GM BEDFORD REMOVAL ACTION SITE SOURCE CONTROL PLAN, ADDENDUM NO. 2

GM POWERTRAIN BEDFORD FACILITY BEDFORD, INDIANA

CONESTOGA-ROVERS & ASSOCIATES

**GM BEDFORD REMOVAL ACTION
SITE SOURCE CONTROL PLAN**
ADDENDUM NO. 2
PARCEL 3 AND 205
SITE WORKS

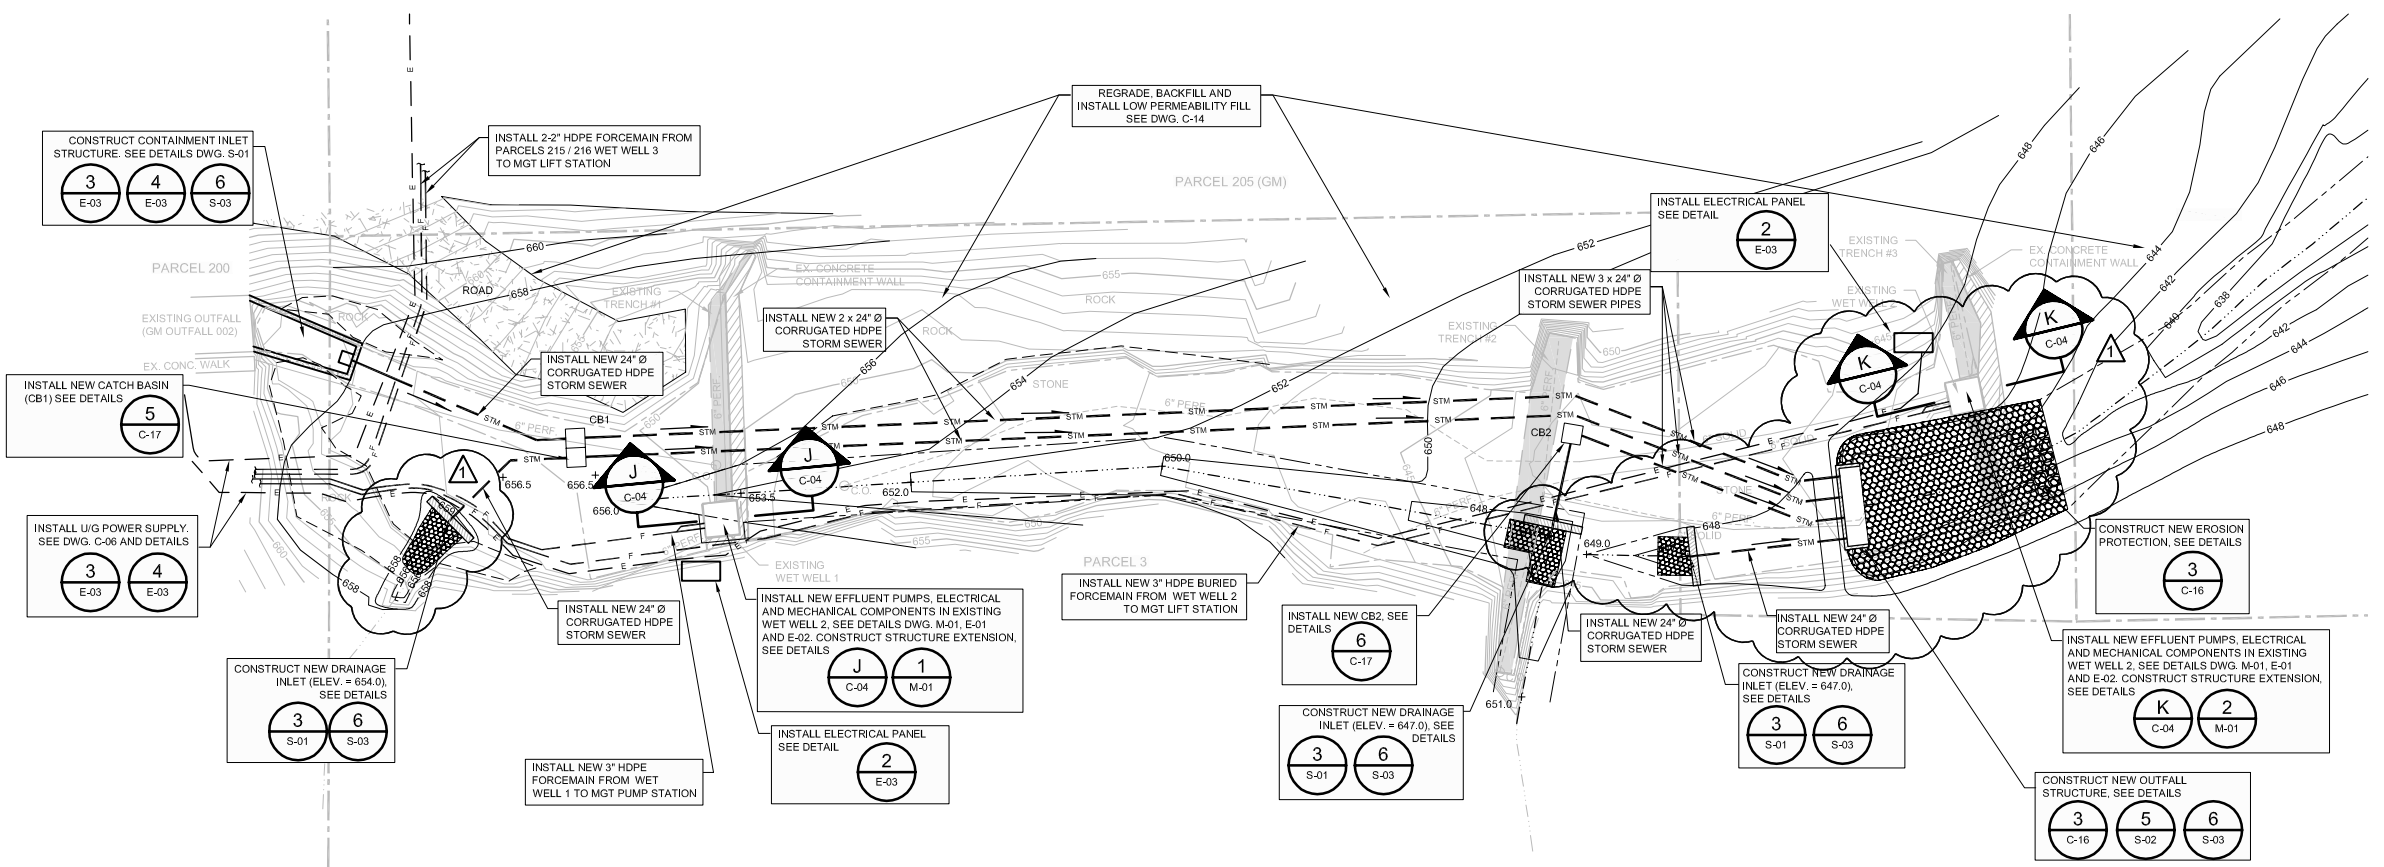
NO	Revision	Date	Initial
1	POSITION OF NEW OUTFALL STRUCTURE AND NEW DRAINAGE INLETS REVISED.	AUG 20, 2004	AW
	PROPOSED CONTOURS REVISED IN AREAS SHOWN

**GM BEDFORD REMOVAL ACTION
 SITE SOURCE CONTROL PLAN**
 ADDENDUM NO. 2
 AREA NORTH OF AOI 4
 SITE WORKS

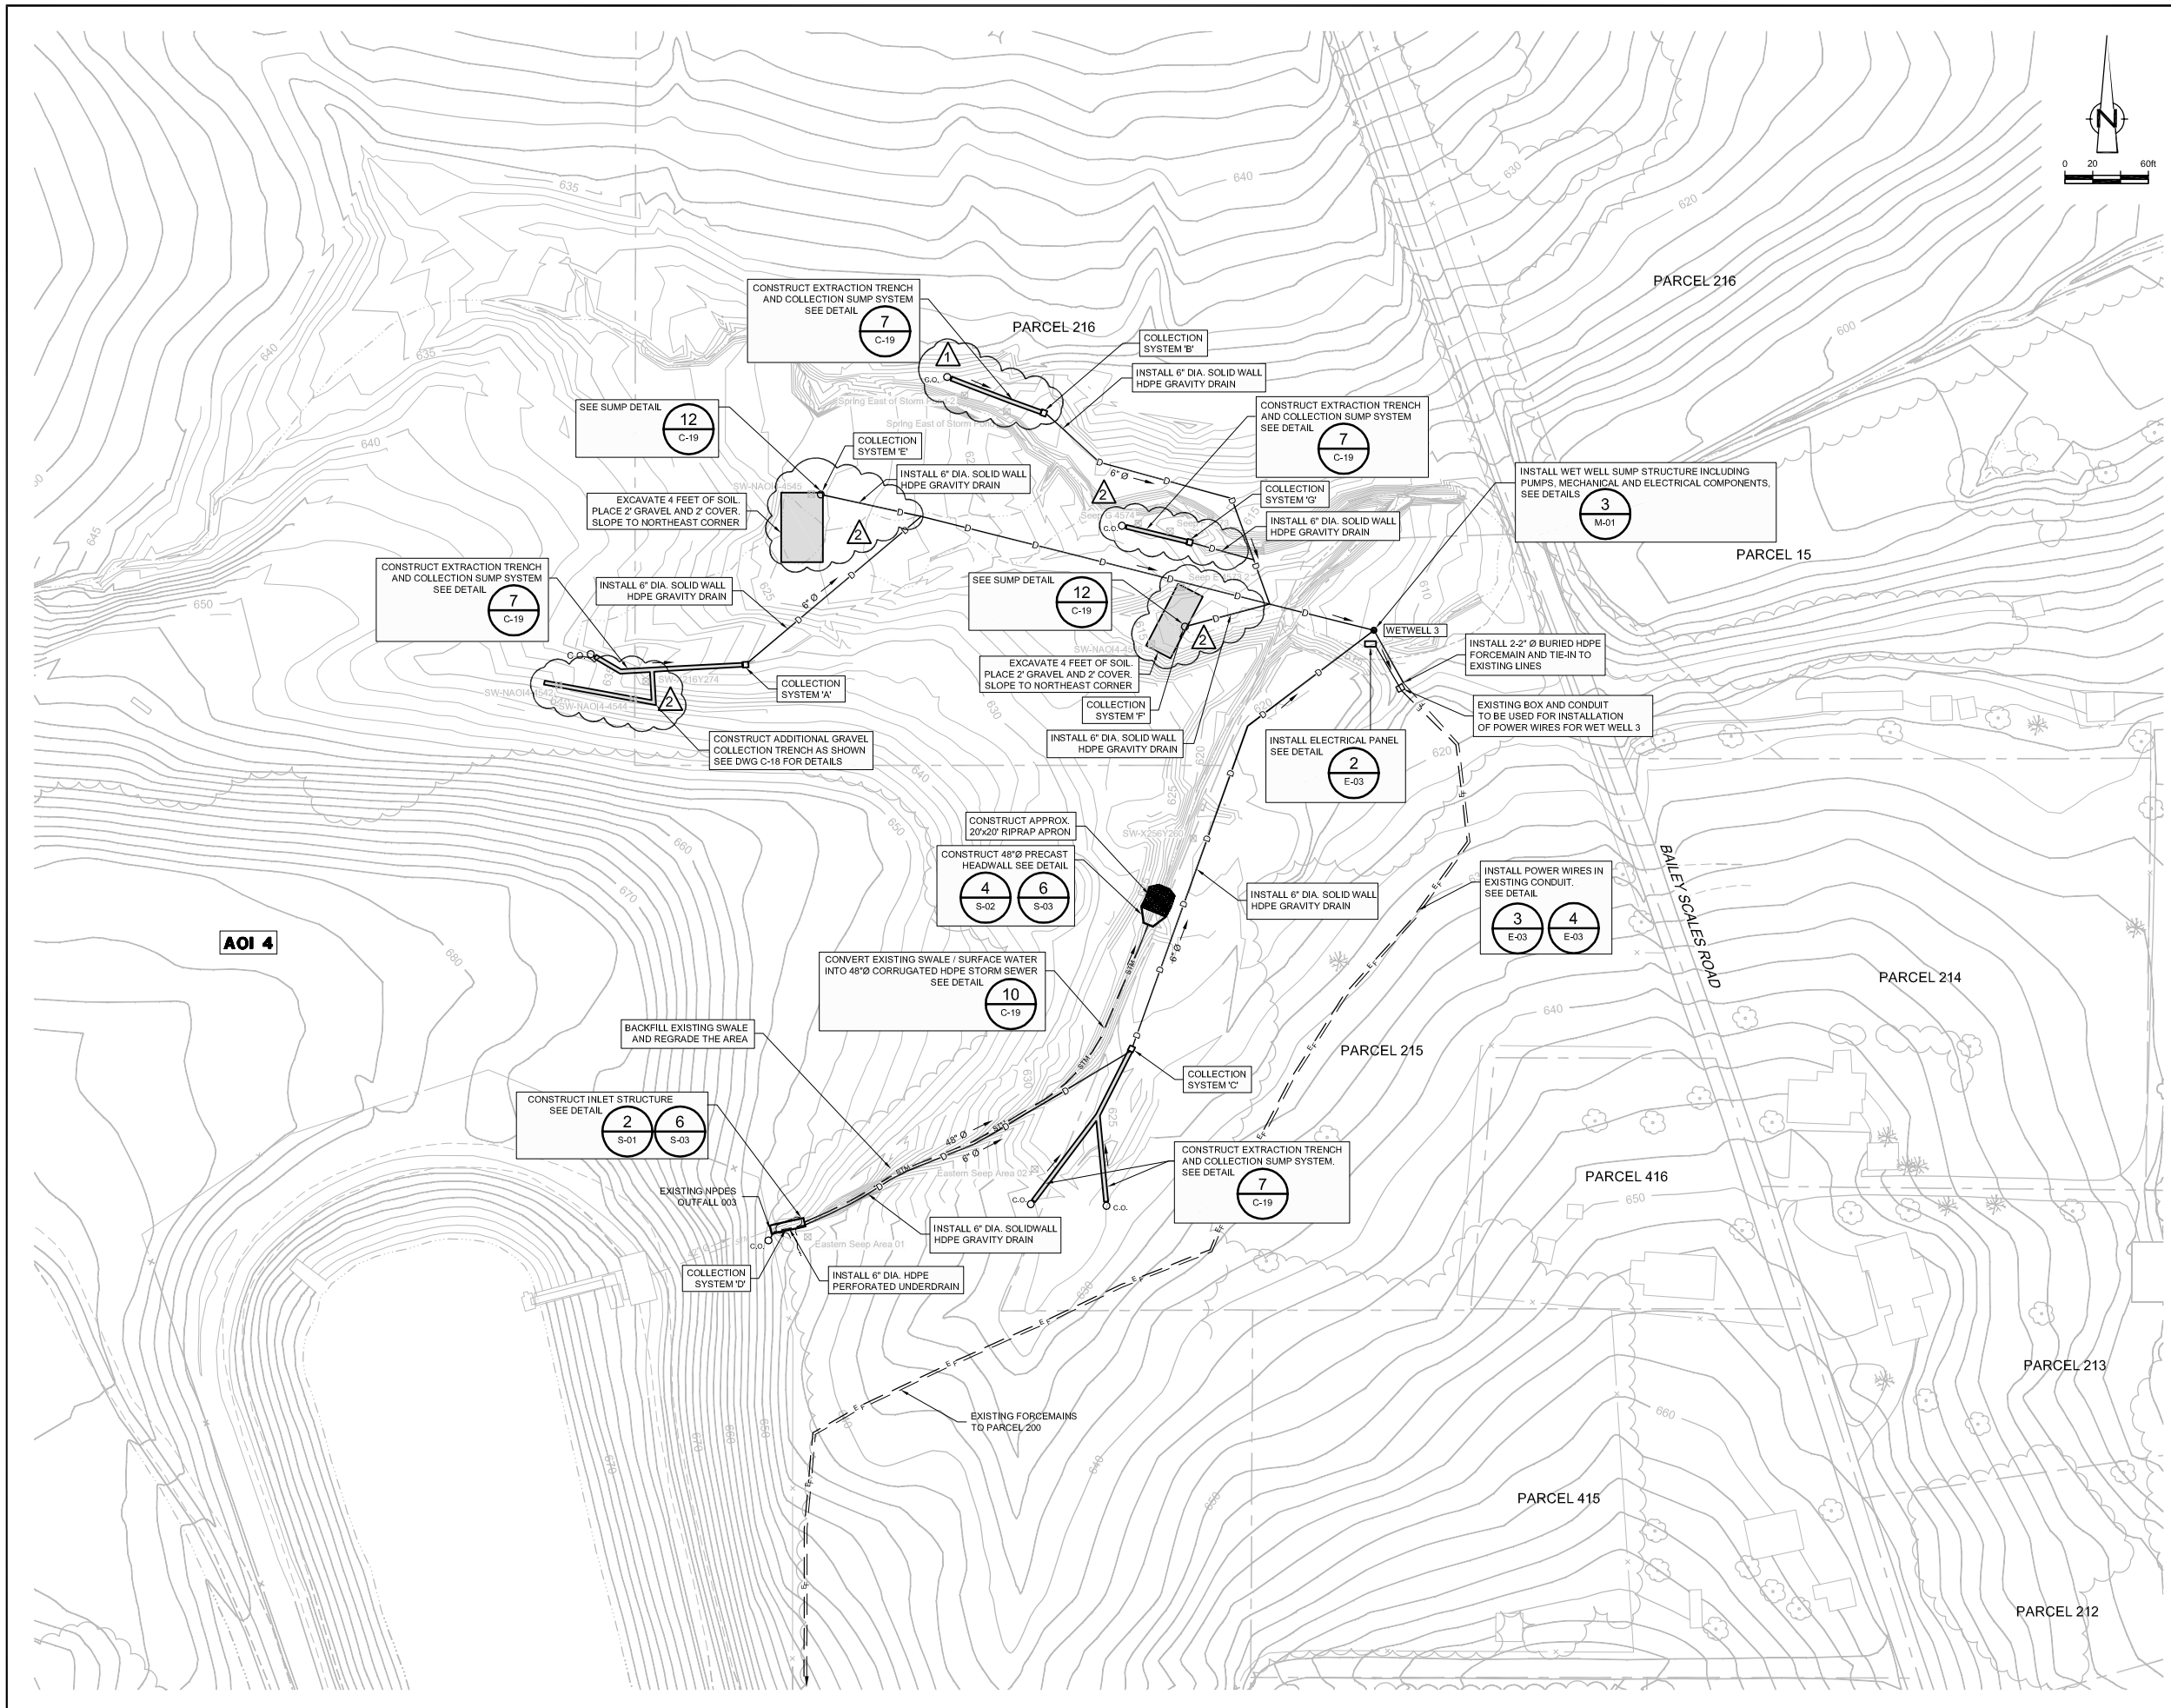
NO	Revision	Date	Initial
1	POSITION OF PROPOSED EXTRACTION TRENCH AND COLLECTION SYSTEM REVISED	AUG 20, 2004	AW
2	ADDITIONAL SEEP COLLECTION AREAS	OCT 18, 2004	CRH

**GM BEDFORD REMOVAL ACTION
 SITE SOURCE CONTROL PLAN**
 ADDENDUM NO. 2
 PARCEL 3 AND 205
 FORCEMAIN PLAN AND PROFILE

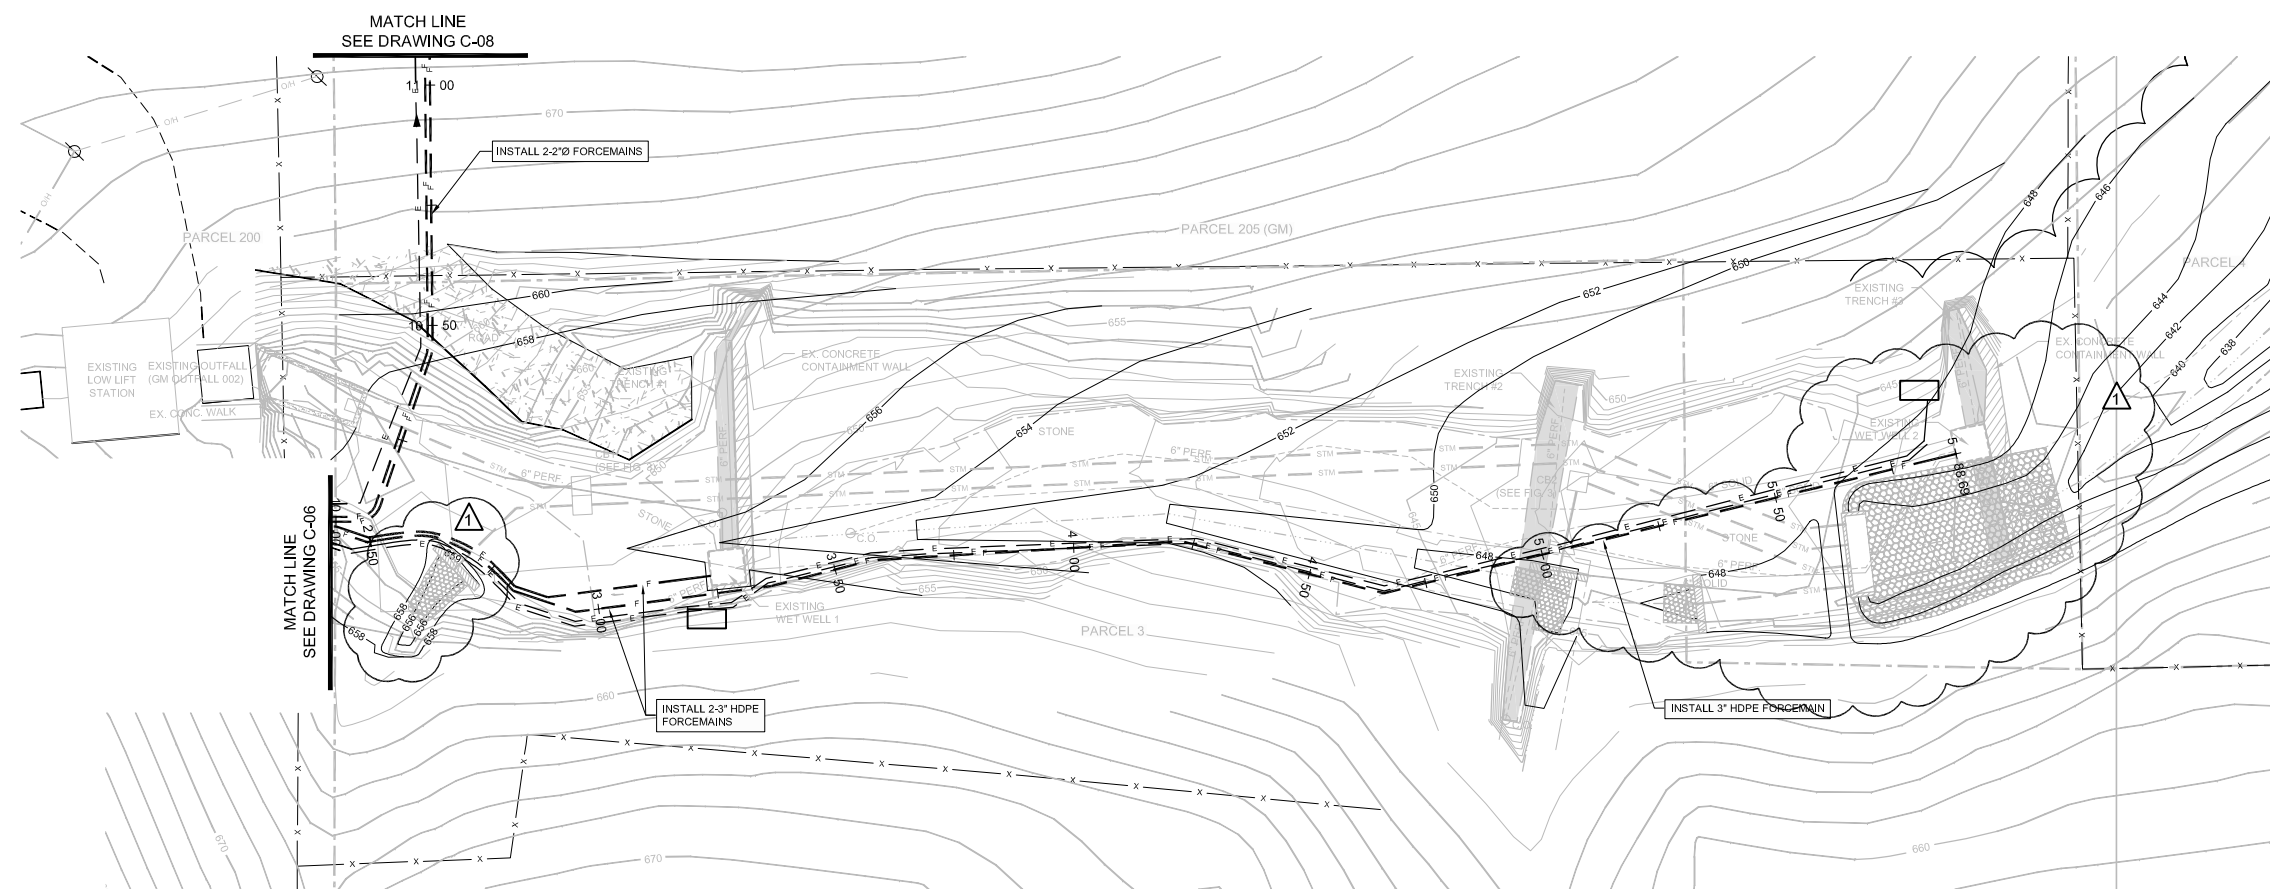
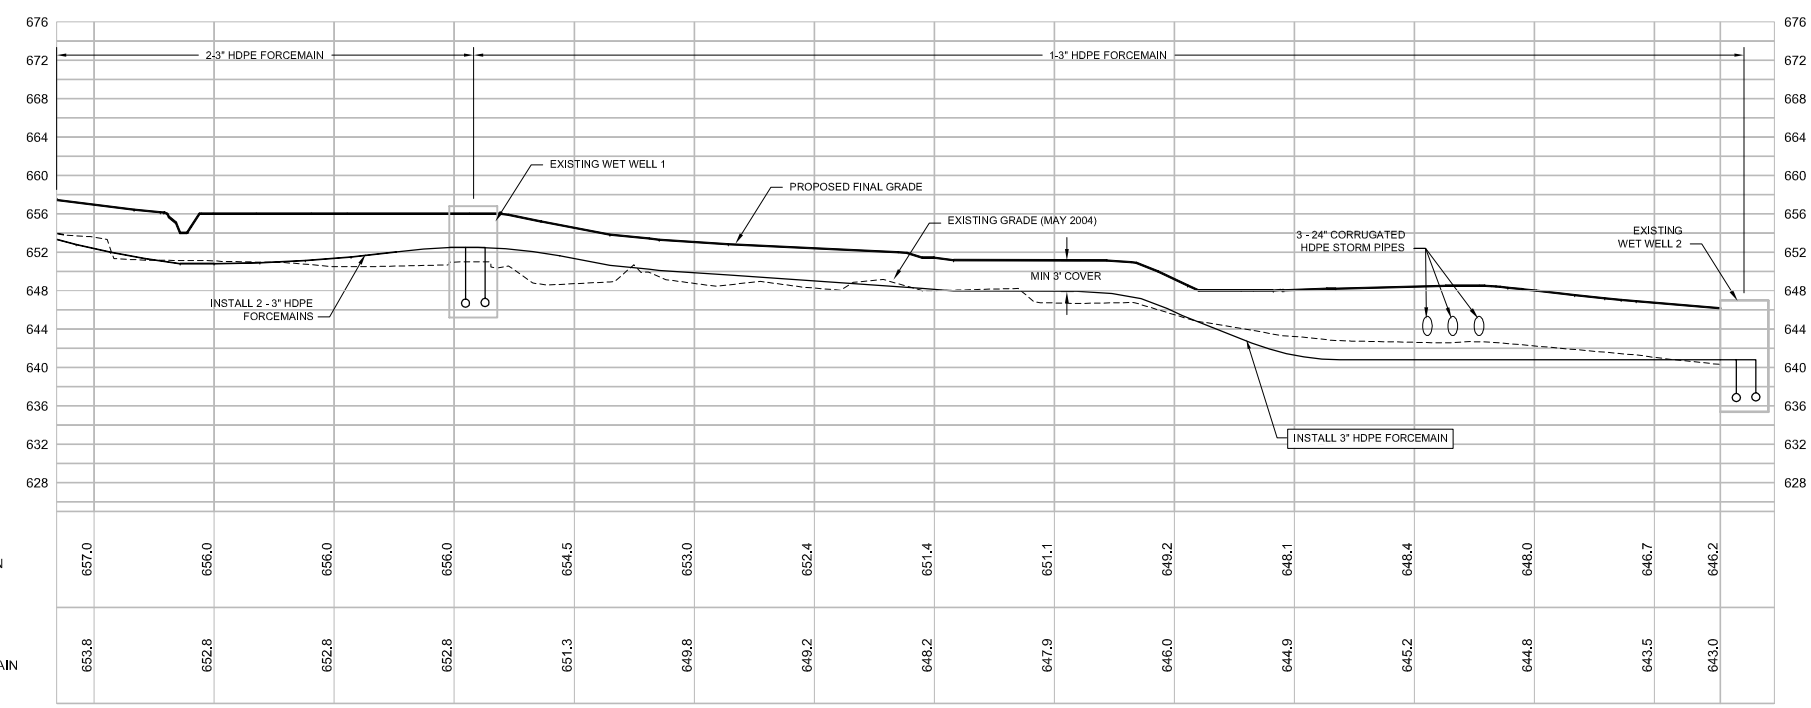
NO	Revision	Date	Initial
1	POSITION OF NEW OUTFALL STRUCTURE AND NEW DRAINAGE INLETS REVISED.	AUG 20, 2004	AW
	PROPOSED CONTOURS REVISED IN AREAS SHOWN

**GM BEDFORD REMOVAL ACTION
SITE SOURCE CONTROL PLAN**
ADDENDUM NO. 2
**PARCELS 3 AND 205
STORM SEWER PLAN AND PROFILE**

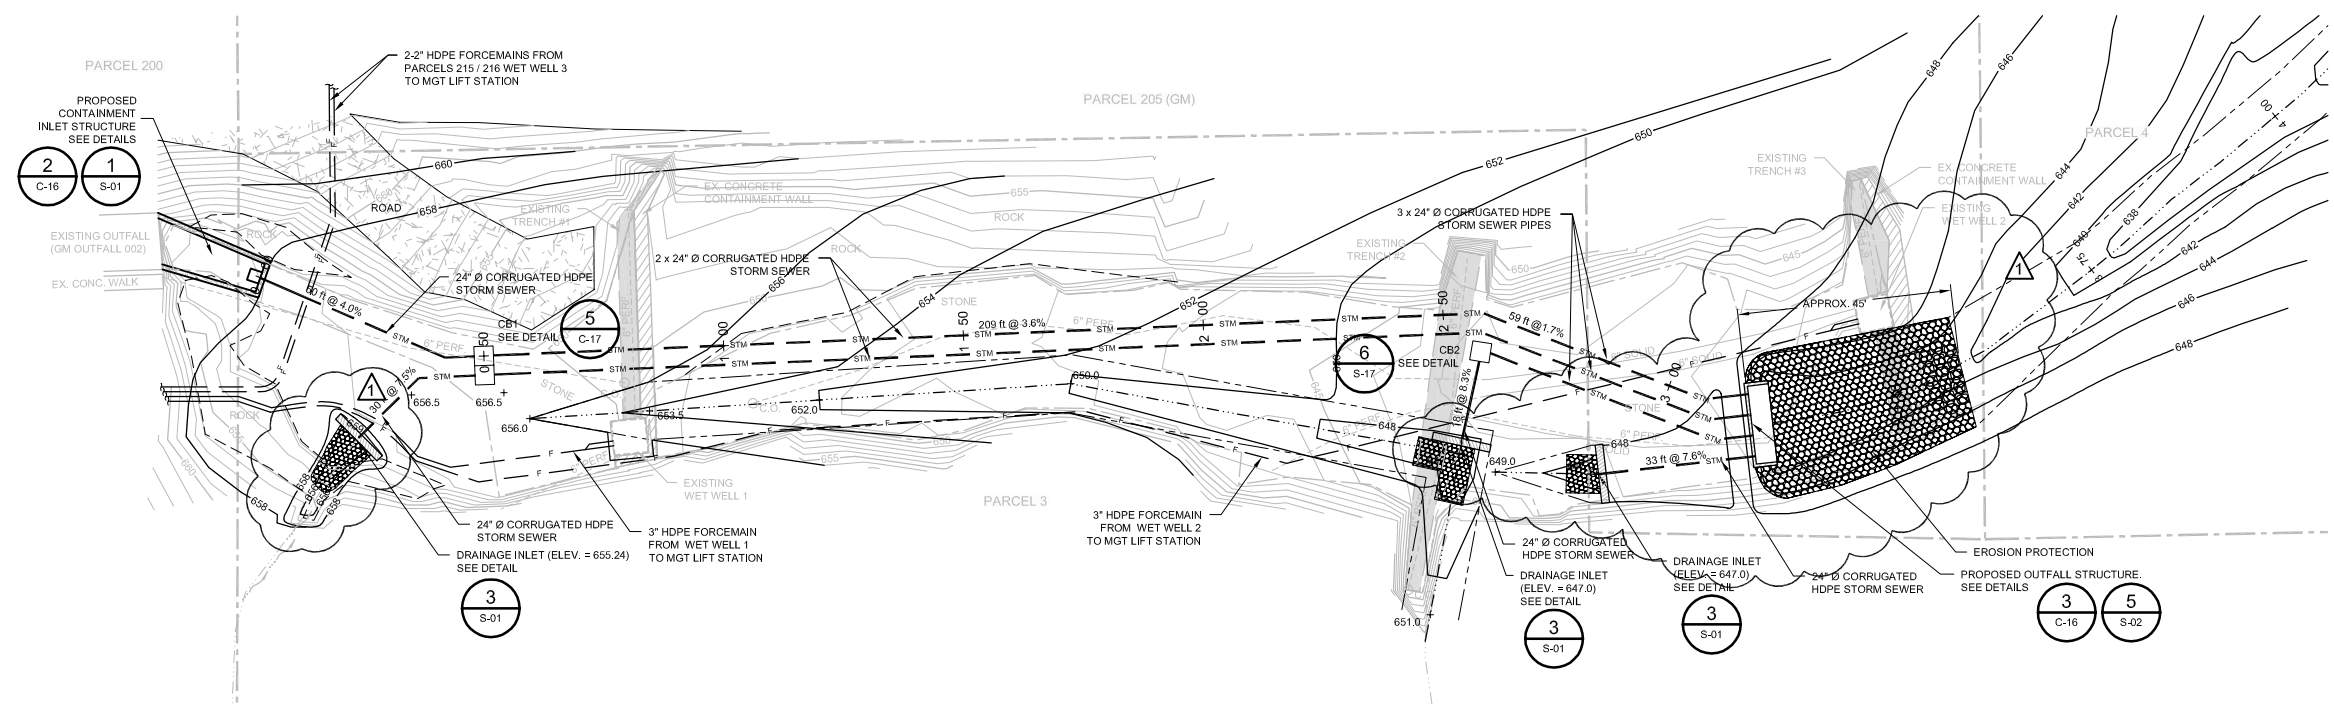
NO	Revision	Date	Initial
1	POSITION OF NEW OUTFALL STRUCTURE AND NEW DRAINAGE INLETS REVISED.	AUG 20, 2004	AW
	PROPOSED CONTOURS REVISED IN AREAS SHOWN		
	STORM SEWER PROFILE AT THE OUTFALL REVISED AS SHOWN
